BOARD ACTION REPORT – APPEALABLE ITEM

Project Name: Lynn Townhomes

Brief Description: Class V Site Plan, Landscape Plan, and Architectural Elevations for the construction of a 3-unit townhome development to be known as Lynn Townhomes and located at 712 NE 8th Avenue.

SITE PLAN REVIEW AND APPEARANCE BOARD STAFF REPORT

DRAWING:
NORTH AND EAST ELEVATIONS
SCALE: 1/4"

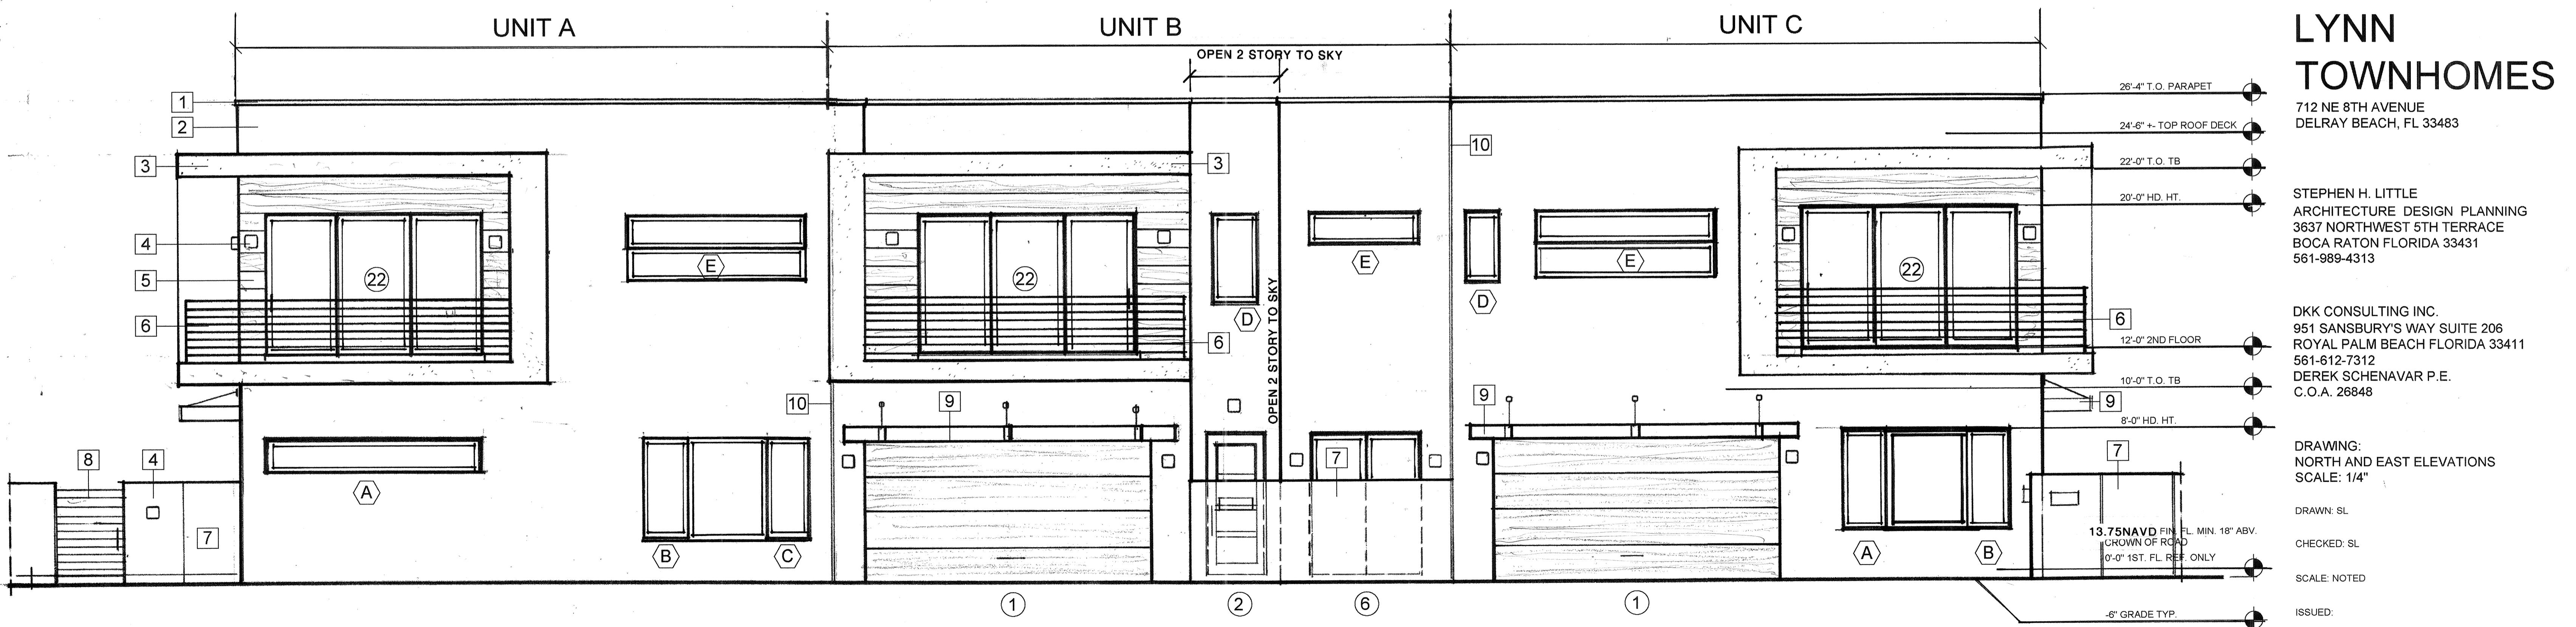
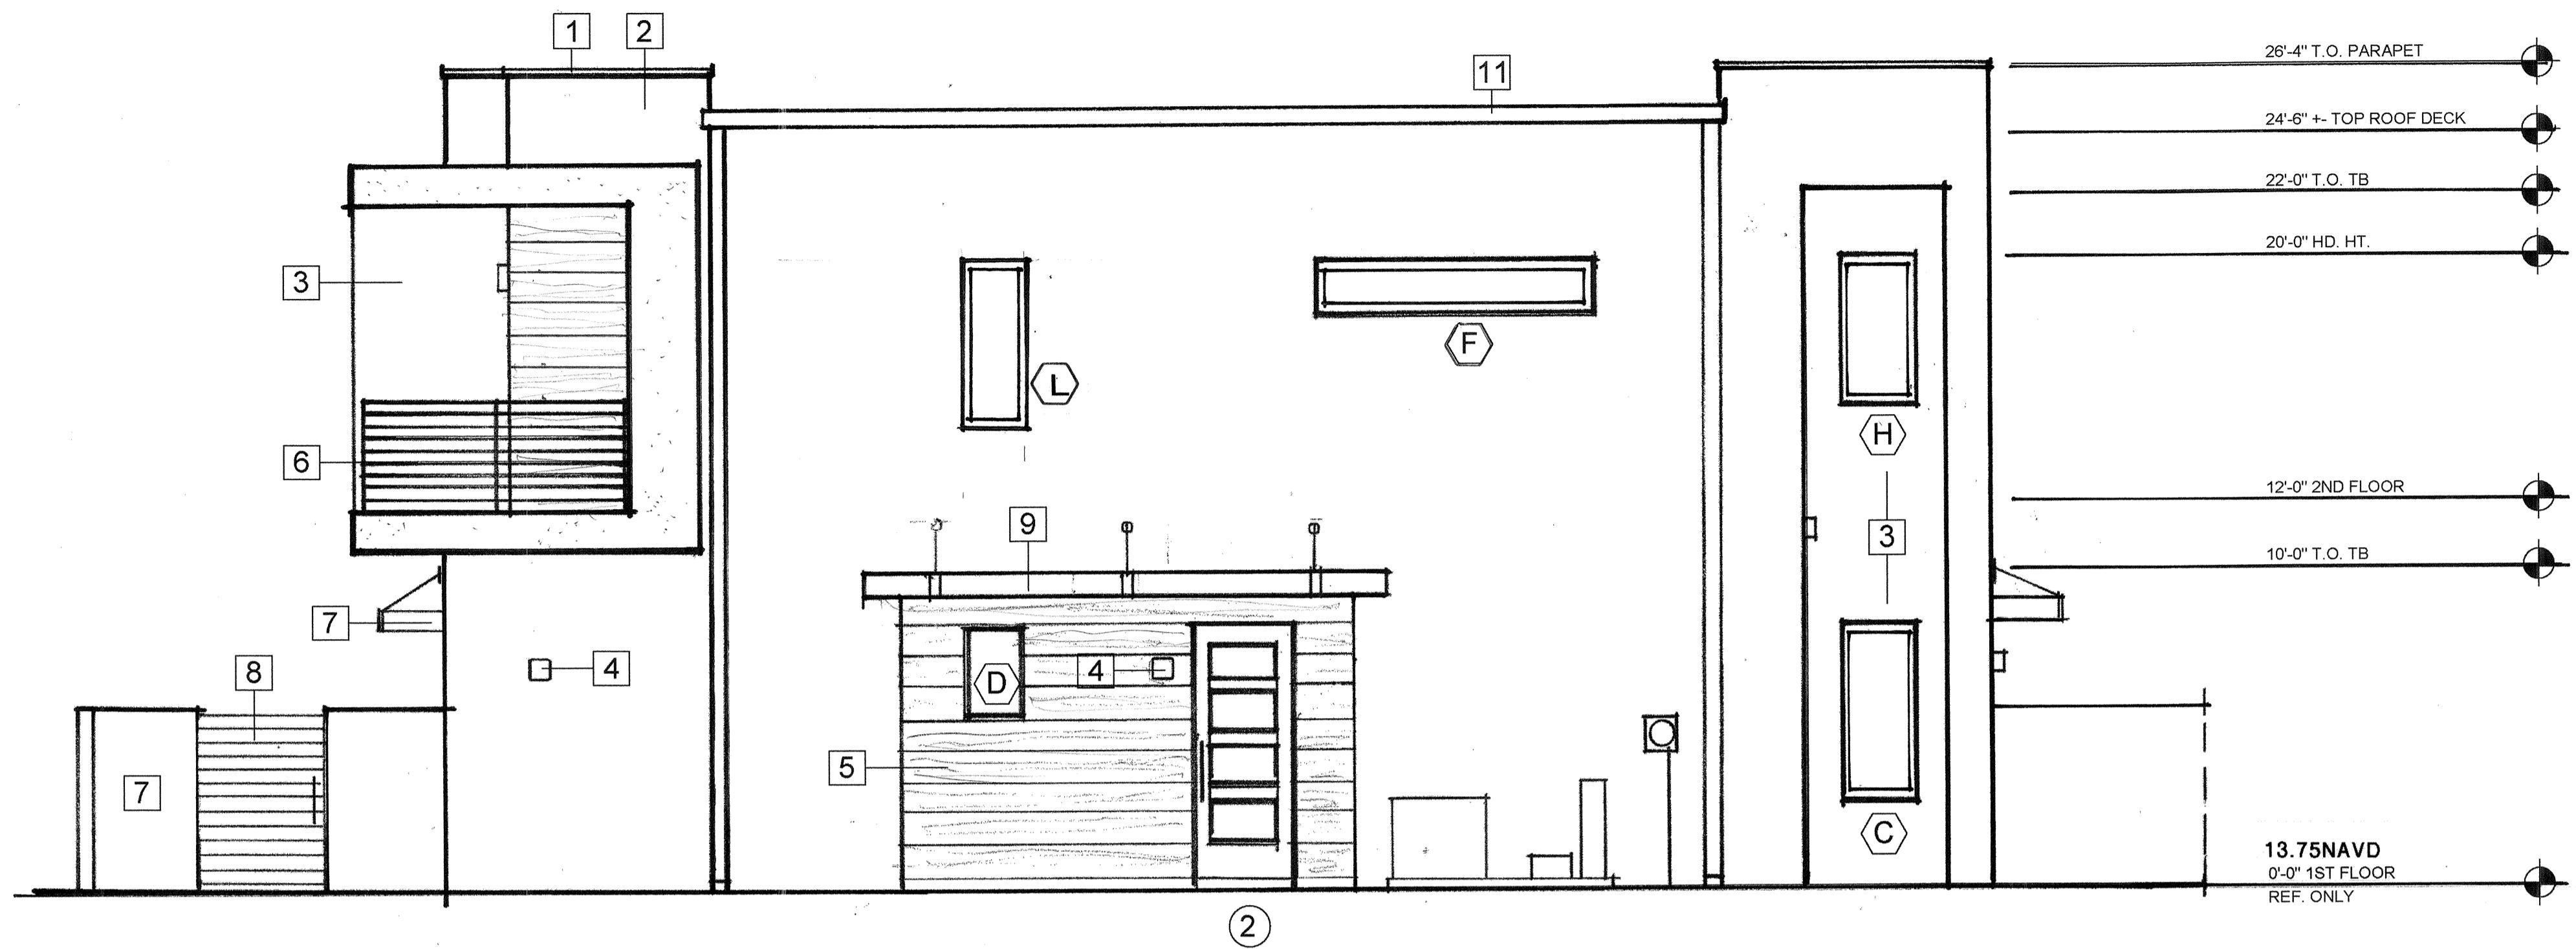
The applicant returned to the Board on April 27, 2022, and a continuance was requested again as the Board still had concerns with the lack of visual appeal due to the blank walls on the north and west elevations and the use of the accent color grey.

The applicant has provided minor architectural elevation changes which include additional window openings on the north elevation and west elevation. The color palette, which remains with the walls in Smooth Stucco in Olympus White, the accent color in Earl Grey, and the railings in Green Black, has not been revised. The applicant indicated that additional colors were considered but the original color scheme was determined to be the most appealing for the architectural style.

The applicant added additional windows on the north and west elevations to add more visual appeal and light to the units and the Board approved the project 6-0 at the July 27th meeting.

REVISIONS:
REV. 1 6/10/22 NORTH ELEV. ADD WINDOWS
